**Technical Analysis and Findings**  
**Utah Coal Regulatory Program**

**PID:** C0410002  
**TaskID:** 4953  
**Mine Name:** SUFCO MINE  
**Title:** WASTE ROCK SITE EXPANSION

CLIENT SUFACO MINE CANYON FUEL COMPANY, LLC	
PROJECT SUFACO MINE C/041/0002	
TITLE <b>WASTE ROCK EXPANSION TASK #4953</b>	
YYYY-MM-DD	2015-08-14
PREPARED	CHERYL PARKER
DESIGN	CHERYL PARKER
REVIEW	AMANDA DANIELS
APPROVED	####
PROJECT Task 4953	MINE Sufco Mine
Ref. C/041/0002	FIGURE <b>1</b>

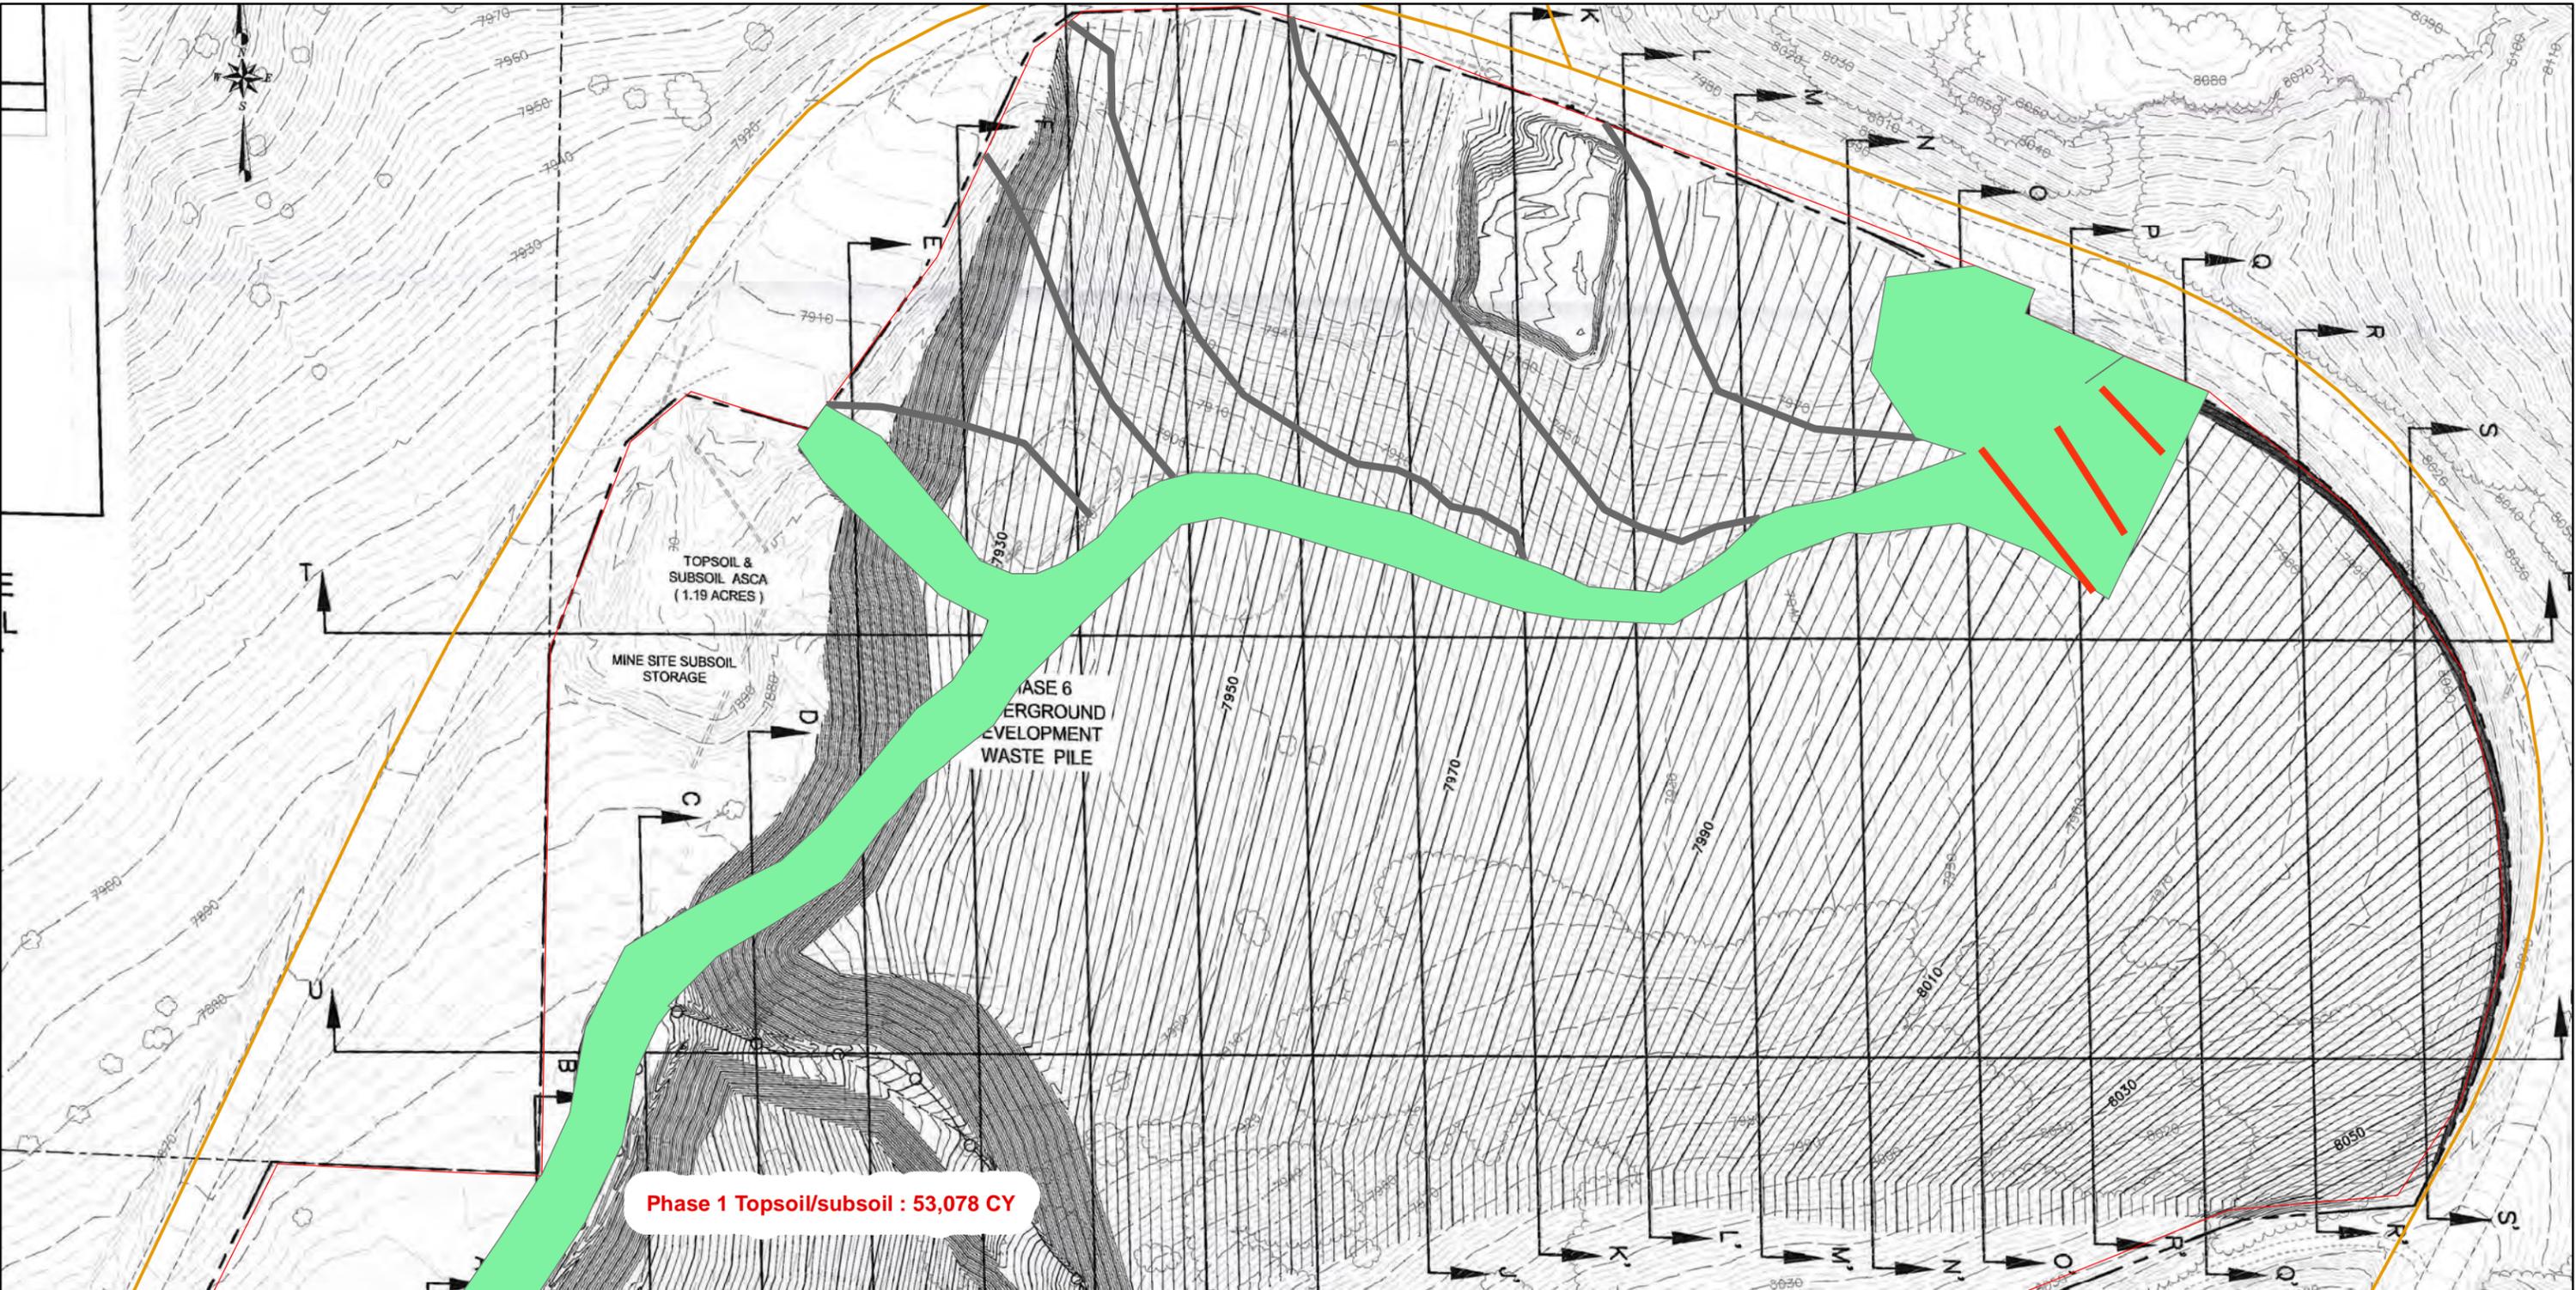
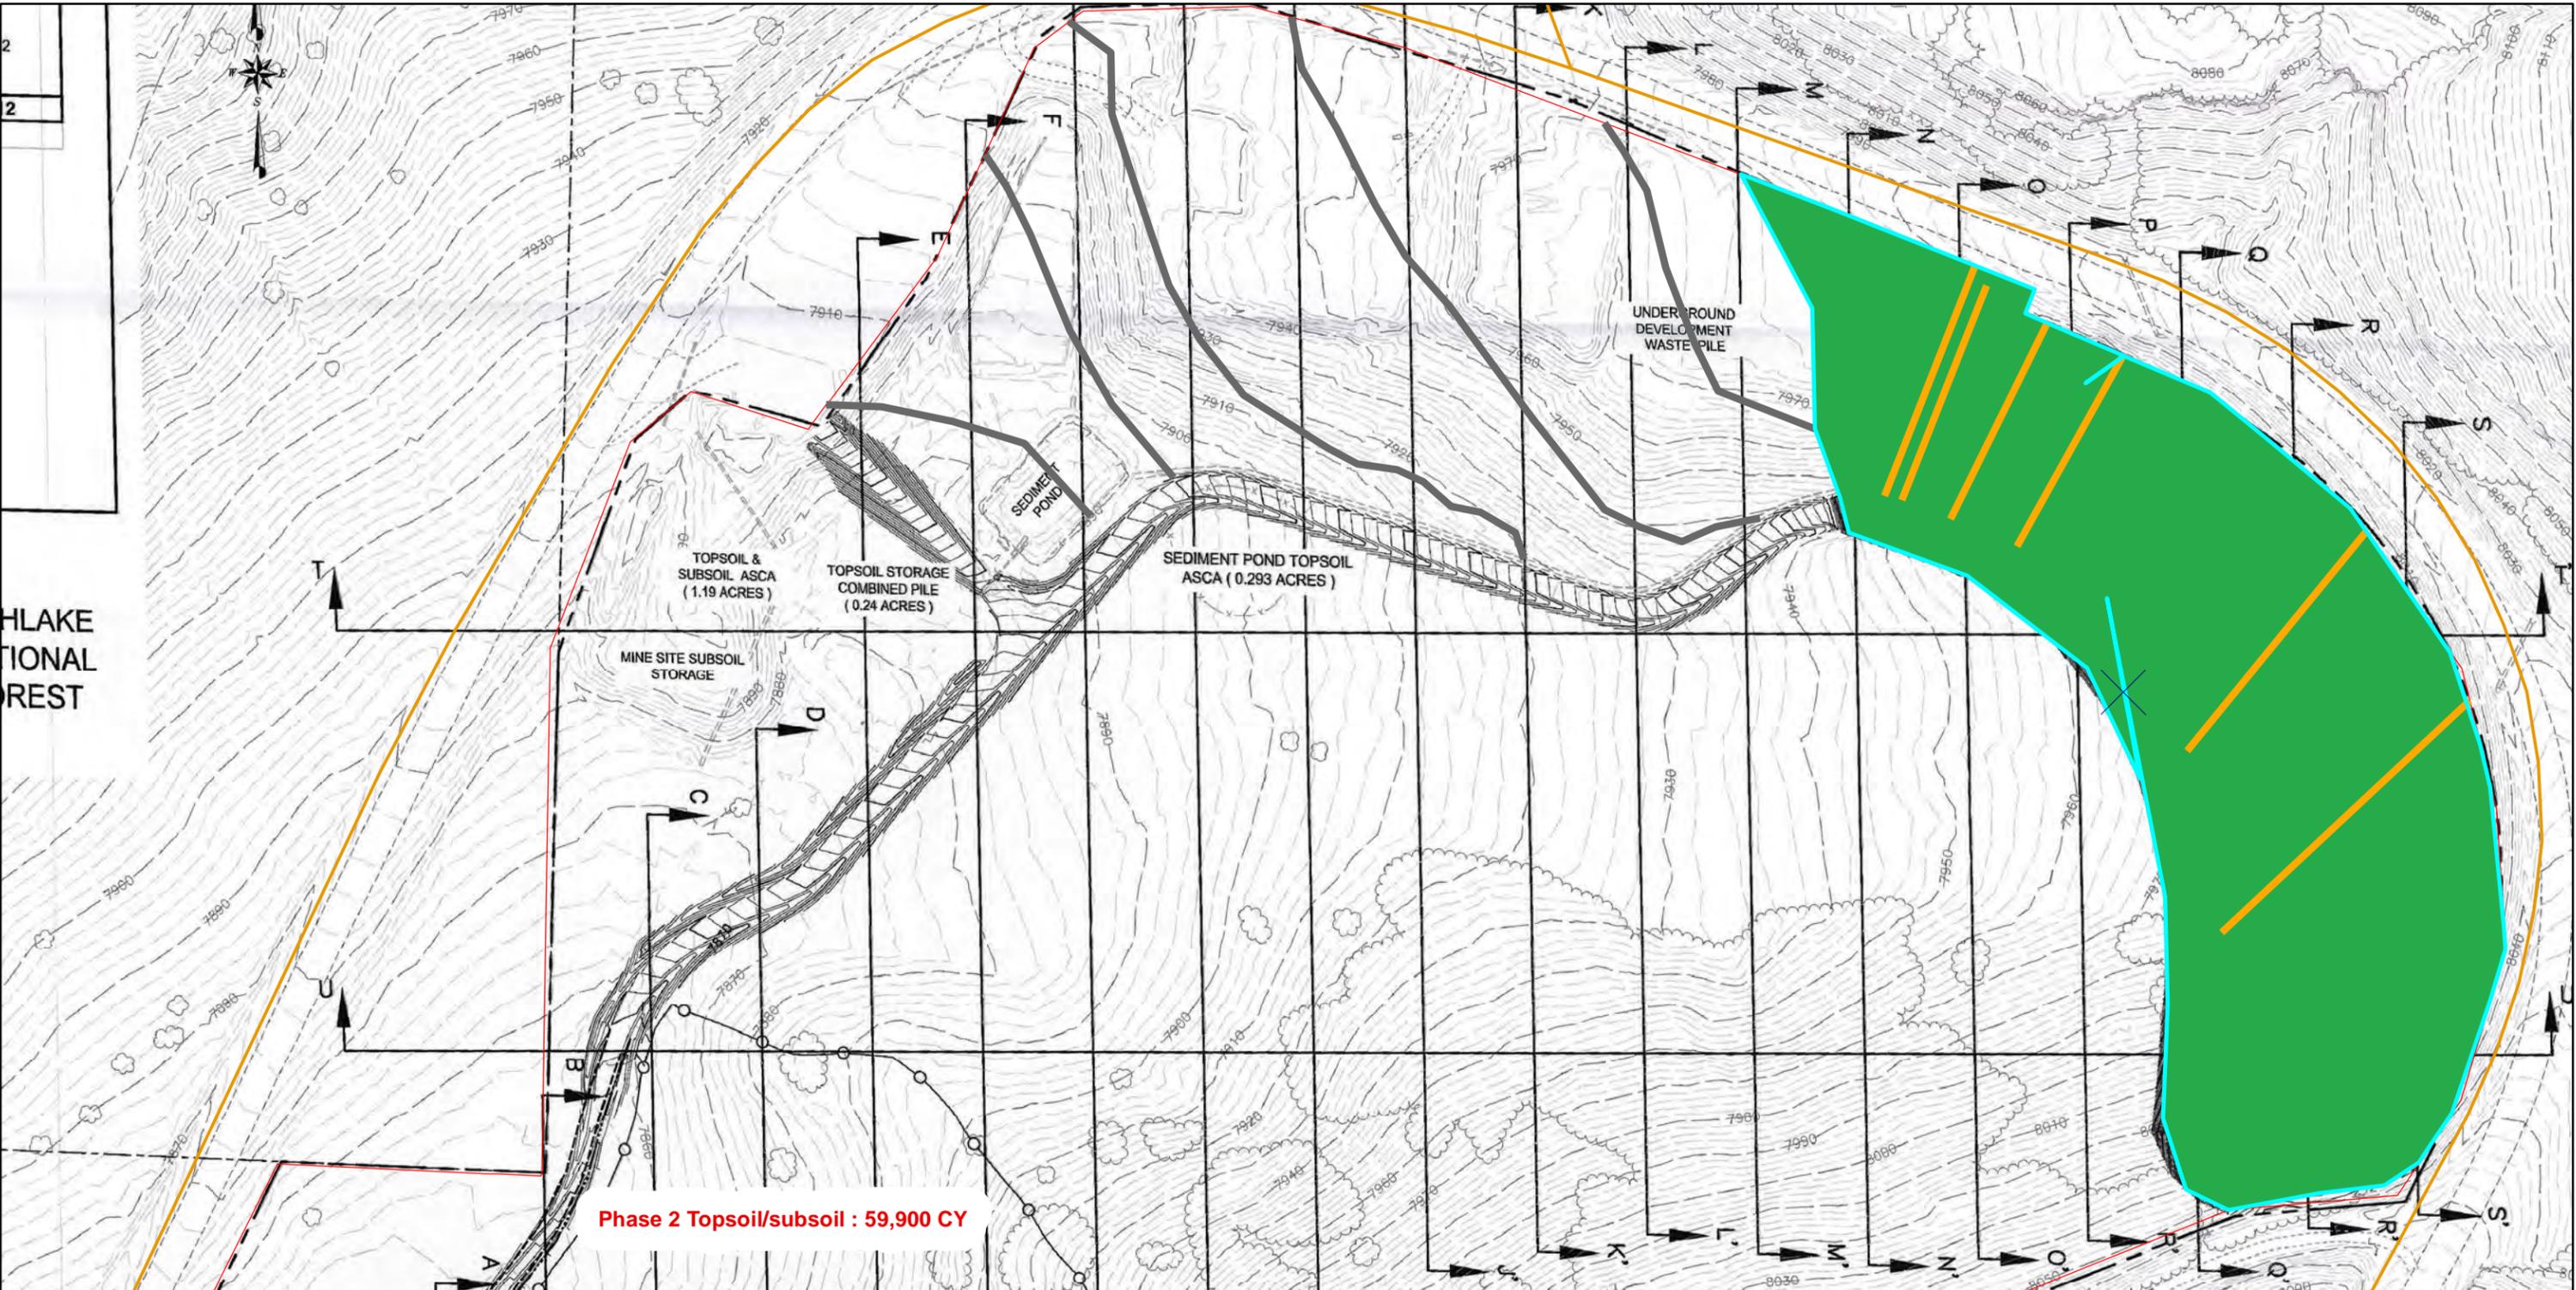
- The application does not detail how the various sequential phases of the waste rock pile will be tied into the existing waste rock pile in the narrative or on Maps 2A through 2E. Maps 2A through 2E, as shown, detail a channel between the existing and proposed waste rock piles as the topography abruptly ends before tying into the corresponding elevation on the existing waste rock pile. Based on the cross section detailed in Map 3A through 3C, the Division believes this is a simple error in the drawings representation of phase areas and the volumes shown on the maps account for the missing void shown on Maps 2A through 2E. The Permittee will amend Maps 2A through 2E to show the proposed operational map tying into existing contours on all sides, as shown on the condensed map on Figure 1 attached.

- Map 4A through 5E shows the approximate footprint area of each phase of the waste rock pile construction, however, they do not detail the area to be worked in the corresponding existing waste rock pile to tie the contours together to achieve a final surface as represented in Map 8. Maps 4A through 5E will be edited to show the complete footprint of where waste rock will be placed including in the proposed waste rock pile and over the existing waste rock pile. See Figure 1 for an approximation of contours.

• The application does not detail how the various sequential phases of the waste rock pile will be tied into the existing waste rock pile in the narrative or on Maps 2A through 2E. Maps 2A through 2E present confusing information as the maps do not show how the proposed waste rock pile will tie into the existing waste rock pile. Maps 2A through 2E, as shown, detail a channel between the existing and proposed waste rock piles as the topography abruptly ends before tying into the corresponding elevation on the existing waste rock pile. Based on the cross section detailed in Map 3A through 3C, the Division believes this is a simple error in the drawings representation of phase areas. The Permittee amend Maps 2A through 2E to show the proposed operational map key into existing contours on all sides.

• Map 4A through 5E shows the approximate footprint area of each phase of the waste rock pile construction, however, the maps do not detail the area to be worked in the corresponding existing waste rock pile to tie the contours together to achieve a final surface as represented in Map 8. Maps 4A through 5E will be edited to show the complete footprint of where waste rock will be placed including in the proposed waste rock pile and over the existing waste rock pile. See Figure 1 for an approximation of contours.
